SUMMARY OF RESPONSES TO REGIONAL BOARD STAFF COMMENTS ON DRAFT WMPS

**For the Lower Los Angeles River and Lower San
Gabriel River Watershed Management Programs**

LARWQCB Public Meeting

April 13, 2015

B1.5. City of Paramount

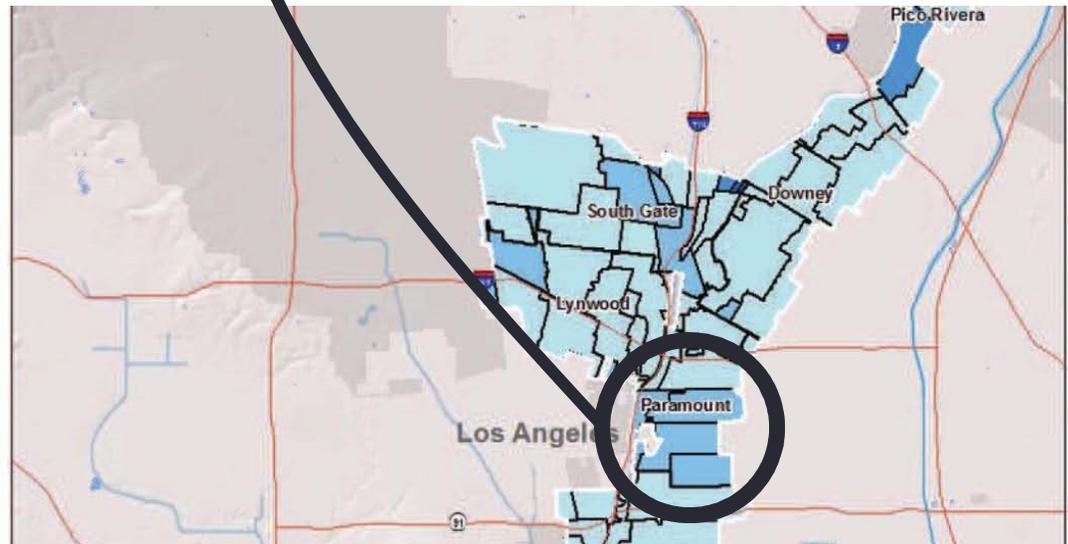
Comment ID		Comment Summary	Response
LLAR LSGR	p3, #3 RAA A.3 p2, #2 p4, #1	Provide more specificity on actions within current and next permit term in order to meet pollutant reductions.	WMP modified to increase degree of clarity and specificity regarding schedules and actions. This effort is the maximum practicable considering associated uncertainties. Greater certainty will be provided through adaptive management. Of particular note: A regional project assessment effort has been added.

LLAR LSGR	p3, #3 p3, #3	Commit to construct necessary # of green street conversions to meet compliance schedule.	See above response. Of particular note: Nexus with Gateway Strategic Transportation Plan has been added.

Subwatershed maps and tables optimize type and placement of BMP for each City

- Groups understand need for specificity
- ROW BMPs:
 - Group does not see utility in listing all potential street projects
 - WMPs provide necessary ROW BMP capacities for each City
 - RAA includes GIS list of prioritized streets for use by Cities
 - **NEW:** WMP states that ROW BMPs will be tied into Gateway Strategic Transportation Plan
- Regional BMPs:
 - **NEW:** WMP commits to Regional BMP assessment in each City
 - **March 2016:** Preliminary site assessment and feasibility study
 - **December 2016:** Field analysis including ground truthing
